GIB® Fire Rated Systems Update

GIB® Information Bulletin
 GIB Fire Rated Systems Update
 September 2012

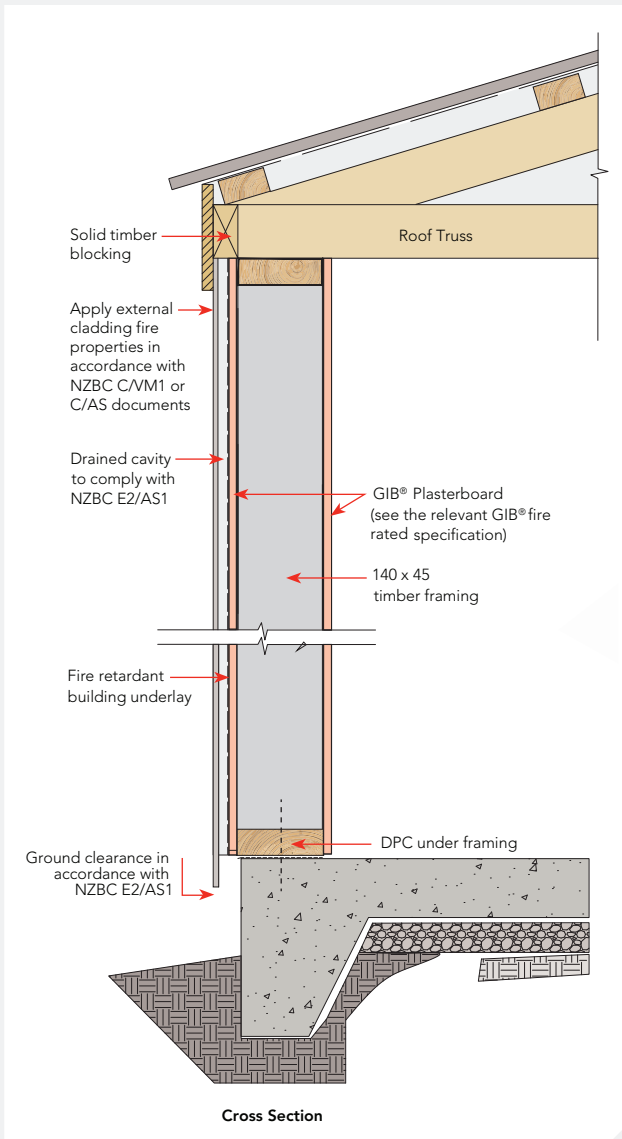
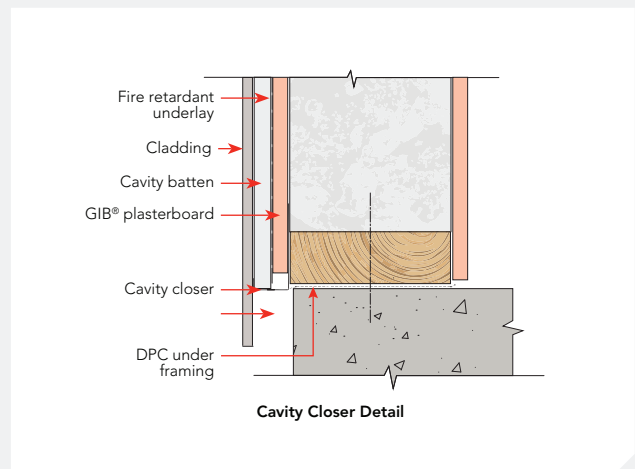
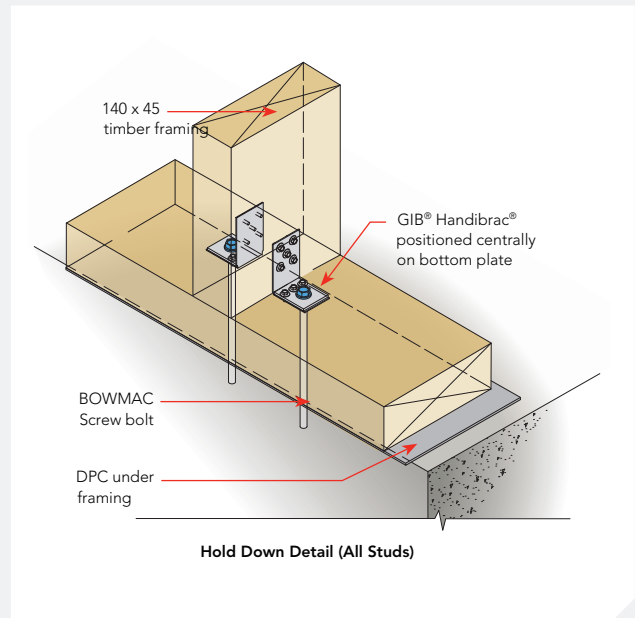
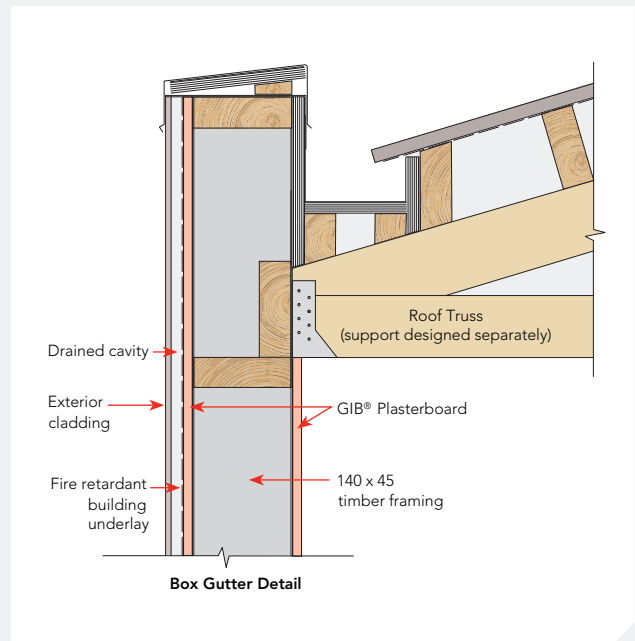
The stud-to-plate and frame-to-slab fixings using GIB Handibrac®s and 90 x 45 mm timber framing, as published in our bulletin 'GIB® Residential Garage

Boundary Walls 2009', provides post-fire stability in the outward direction, but does not prevent collapse inwards. To achieve equal post-fire stability in both directions, use minimum 140 x 45 mm SG8 timber framing and place the GIB Handibrac®s centrally as illustrated.

The drawings below assume a standard wall height of 2.4 m, minimum stud dimensions of 140 x 45 mm and studs at 600 mm centres.

Walls from 2.4 to 3.0 m in height require studs at 400 mm centres. Framing details must be in accordance with NZS3604:2011 and the cladding must be installed in accordance with NZBC E2/AS1. Claddings over GIB® plasterboard must be installed over a fire retardant building underlay and drained cavity complying with NZBC E2/AS1.
